FW: Dec. IDC Mtg.

The IDC should review the home plan for Lot 11-2 as any other homesite sold to an Assembly member.

Below are my notes for 11-2:

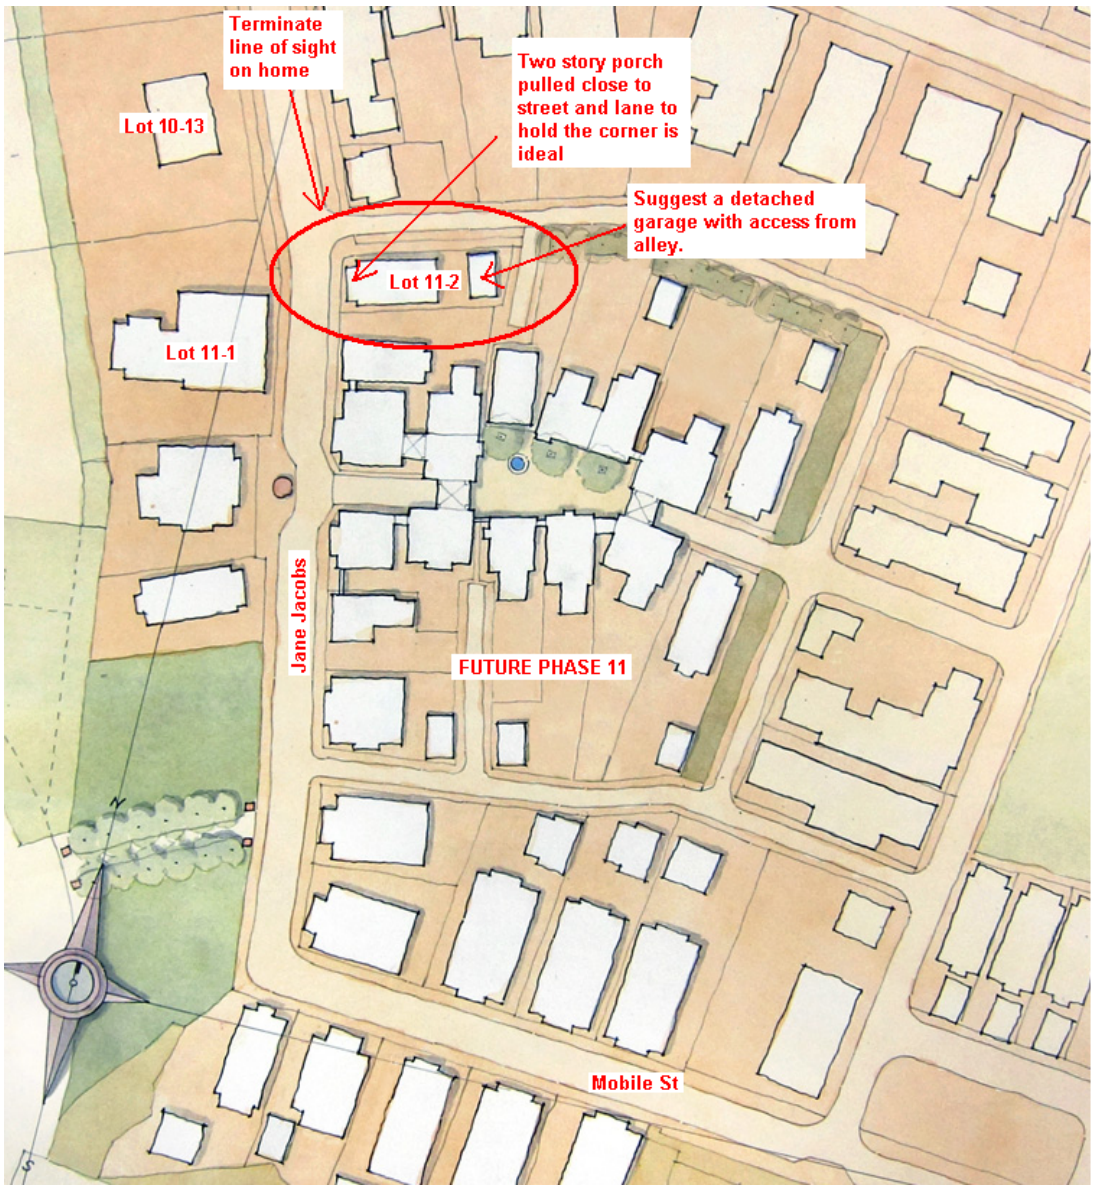
Terminate line of sight on home
Two story porch pulled close to street and lane to hold the corner is ideal
Suggest a detached garage with access from alley.
Lot 10-13
Lot 11-2
Lot 11-1
Jane Jacobs
FUTURE PHASE 11
Mobile St
